GREAT LAKES INDIAN FISH AND WILDLIFE COMMISSION

August 11, 2015

Re: Comments on PolyMet mine site contaminant northward flowpath and groundwater model calibration.

Figure 2 - Profile of the water table between the upper Partridge and the P-M pits under 2 scenarios of water level in the pits.

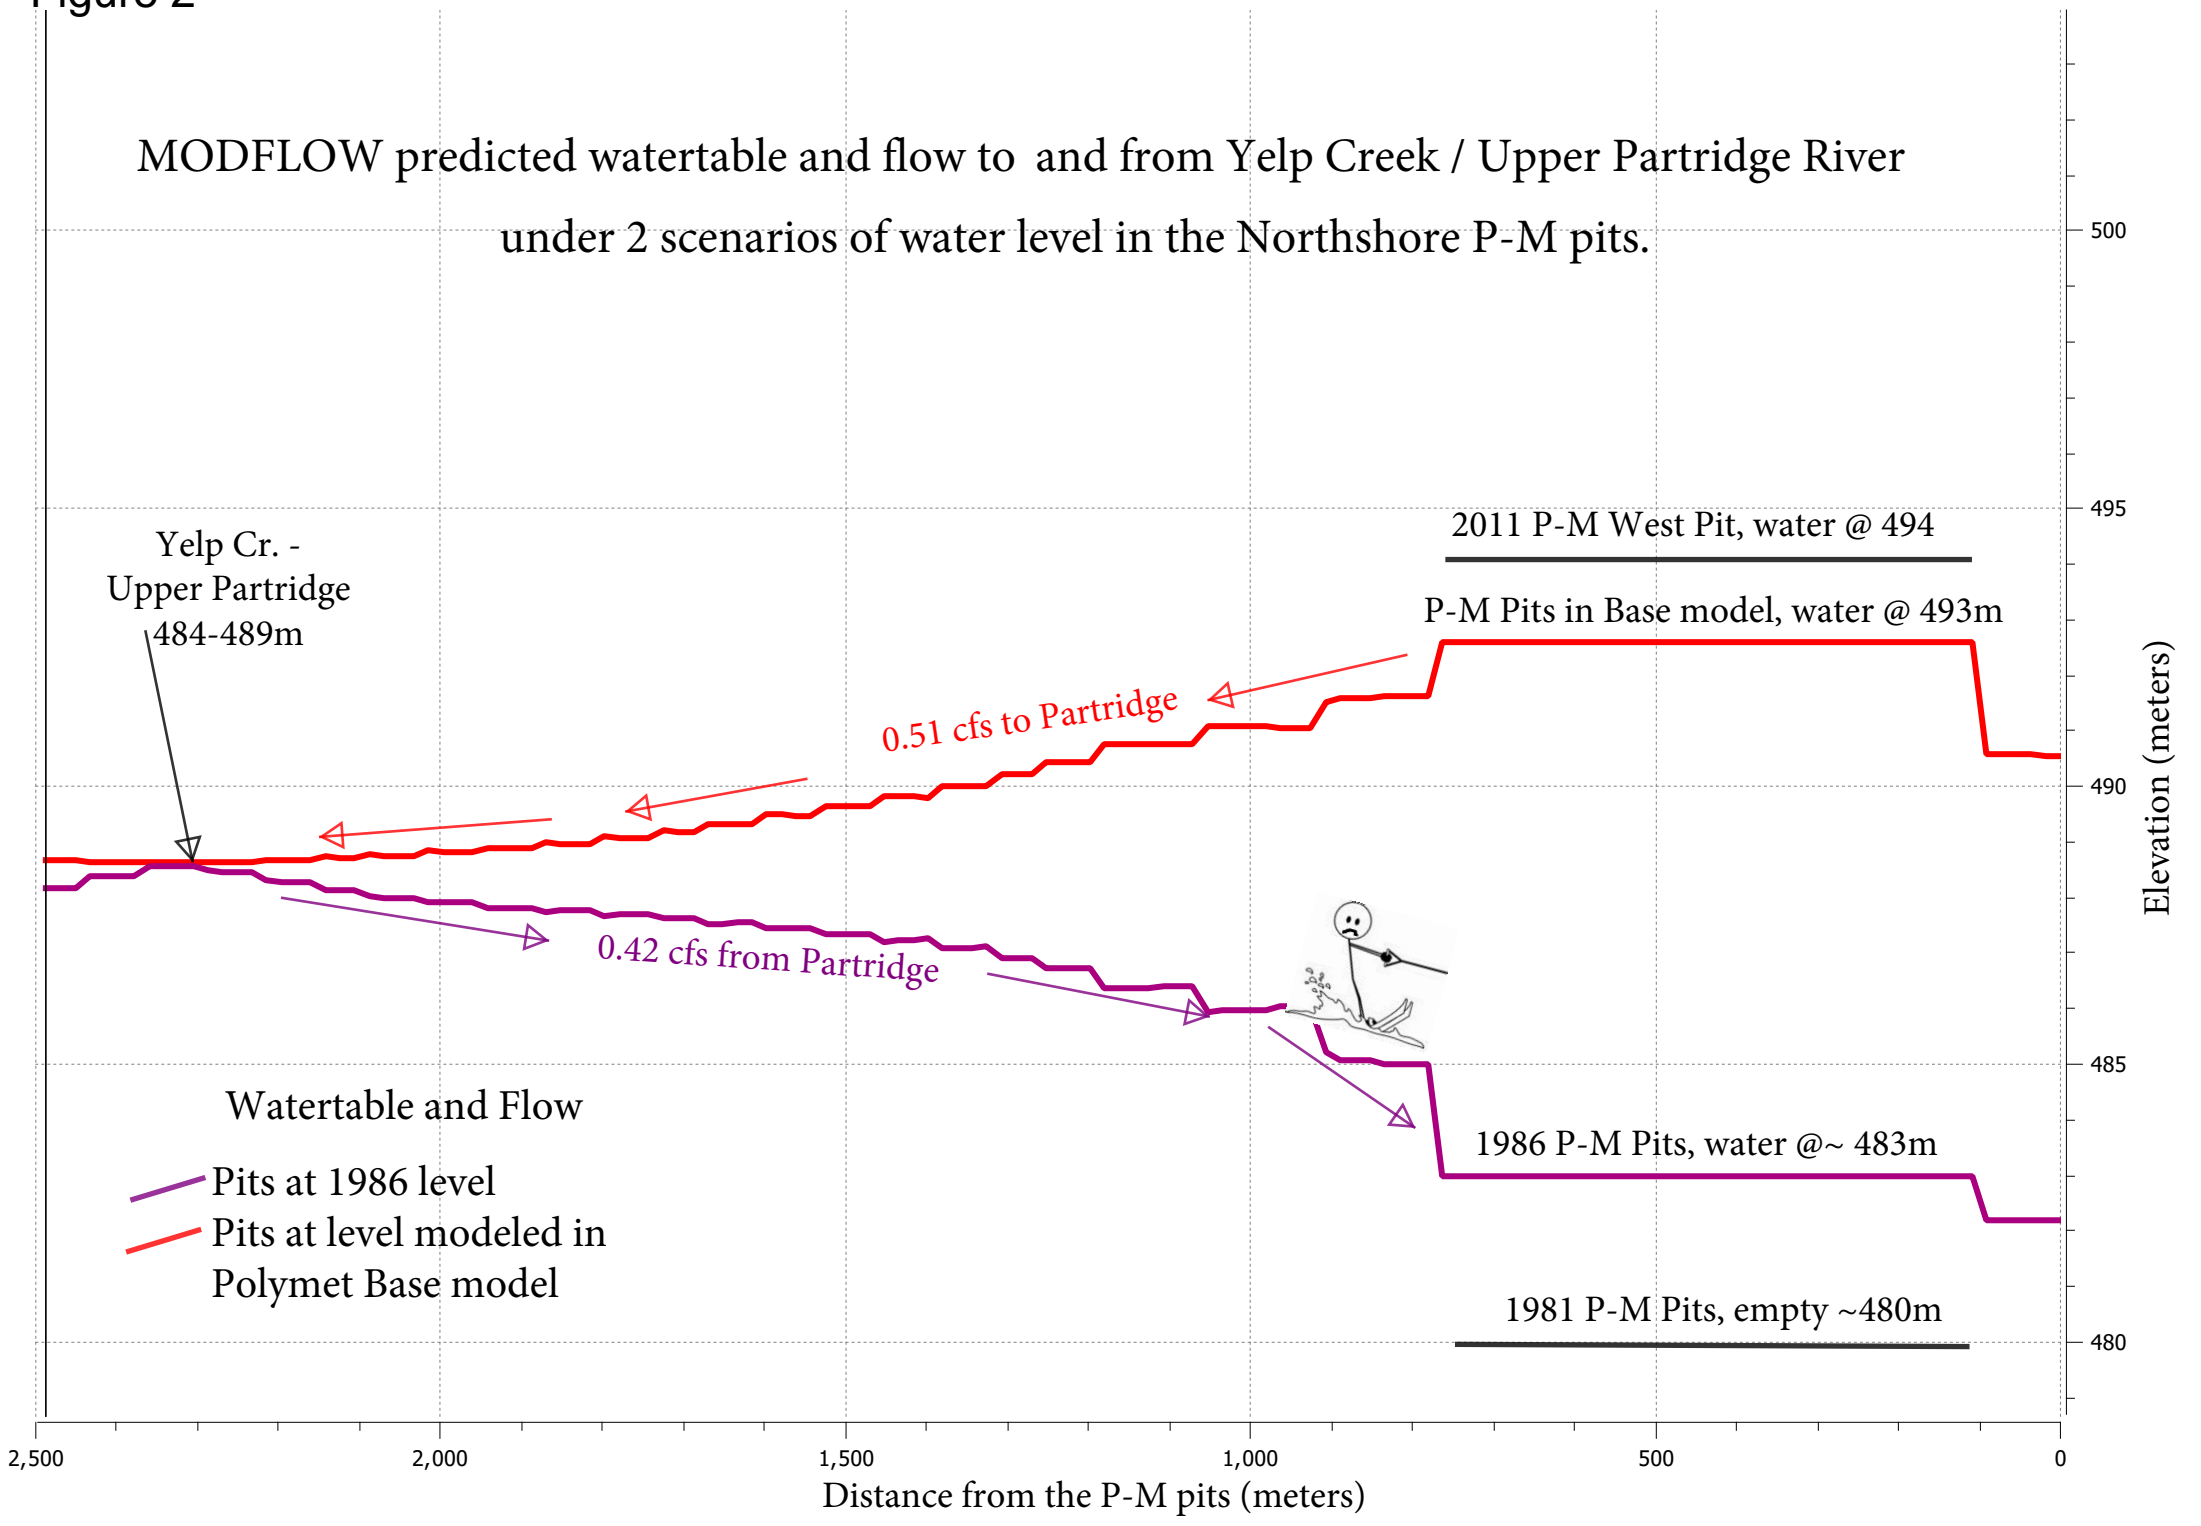
Attached is a figure that shows the predicted water tables and groundwater flow between the upper Partridge and the P-M pits when the P-M pits are set at different levels (attached as Figure 2). In red are the project model results used in recent and past project reports. In those models the P-M pits are assumed to be at their 1996 elevation of 493 meters. The 483 meter model (in purple) is the same as the project model except that the water levels in the P-M pits, that are adjacent to the upper Partridge, are set to 483 meters. An average pit water elevation of less than 480 meters appears to be the correct elevation for the calibration period of 1979-1988 (attached as Table 1). Calibration and use of the MODFLOW model with the P-M pits erroneously set to the unusually high conditions in 1996 (493 meters) is a problem for the following reasons:

As the diagram shows, with the pit water levels that occurred in November of 1986 (i.e. ~483 meters), the upper Partridge would have been losing water to the pits and would have had no baseflow. The water table would have sloped down northward from the Partridge River toward the P-M taconite pits. This is because the riverbed of the upper Partridge River is at 486-489 meters elevation, whereas the water levels in the adjacent P-M pits were at approximately 483 meters elevation in 1986. Average water levels in the P-M pits during the 10 years for which baseflow was calculated (1979-1988) were *even lower* than the 483 meter elevation found in 1986.

The red stair-step line in the figure is the water table between the upper Partridge R. and the Peter-Mitchel taconite pits when the pits are at 493 meters elevation. Water is flowing from the pits to the upper Partridge R.

The purple stair-step line is the water table between the upper Partridge R. and the Peter-Mitchel taconite pits when the pits are at 483 meters elevation (the elevation that they had in 1986). In the 483 meter model run, water is flowing from the upper Partridge R., to the P-M pits.

Large Figure 28
**MINE SITE GROUNDWATER
 FLOW PATHS - SURFICIAL AQUIFER**
 NorthMet Project
 Poly Met Mining Inc.
 Hoyt Lakes, MN

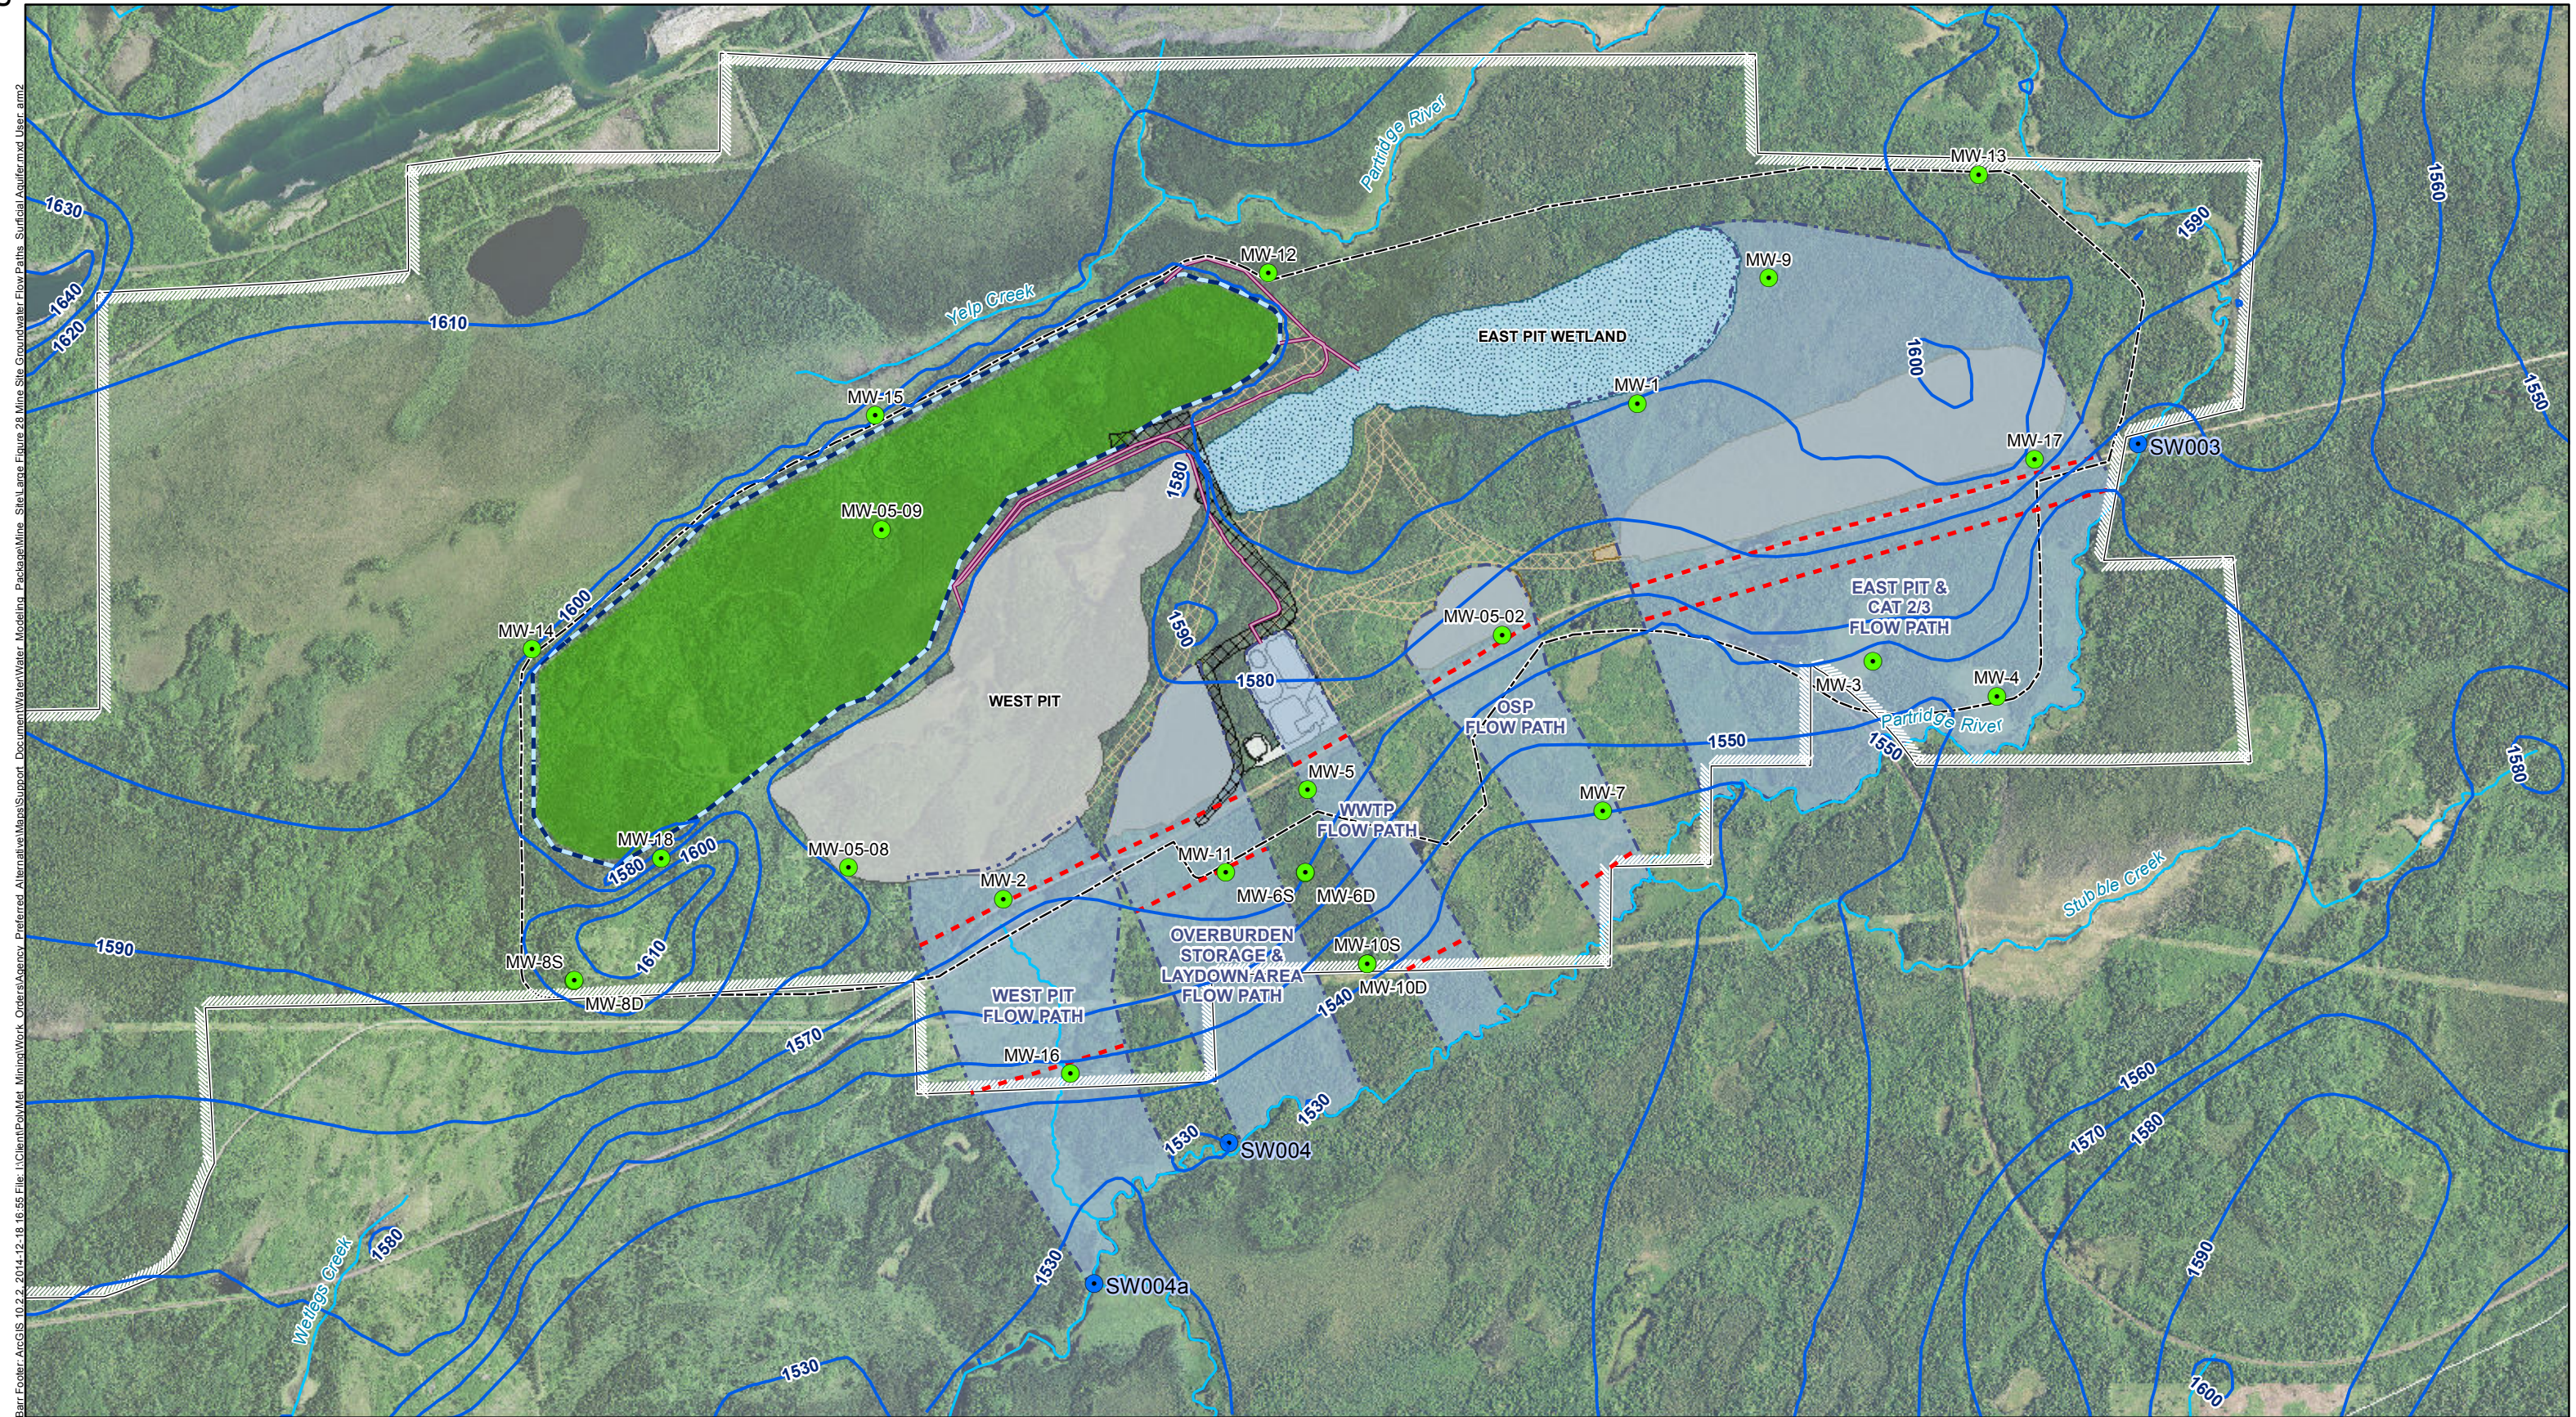
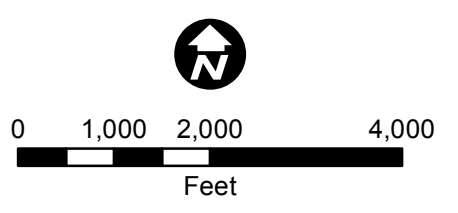
The project MODFLOW model was used to characterize the general nature of the groundwater system such as mine site head distribution (e.g. watertable, Large Figure 14 of the WMDPv13, attached as Figure 12), groundwater levels at closure (e.g. Large Figure 30 of Attachment B of WMDPv13, attached as Figure 13) and contaminant flow paths (Large Figures 28 & 29 of the WMDPv13, attached as Figures 3 & 4). In addition, the MODFLOW model was used to supply the numeric input parameters to the GoldSim model that is used for prediction of contaminant flow and contaminant concentrations (WMDPv13, Table 1-1). That table, attached as Table 4, identifies approximately 12 critical GoldSim input parameters that are outputs from the mine site MODFLOW groundwater model. Of those twelve,

Large Figures 28 and 29 of the Water Modeling Data Package Vol_1-Mine_Site_v13_DEC2014, .pdf pages 510 & 511 (contaminant flowpaths)
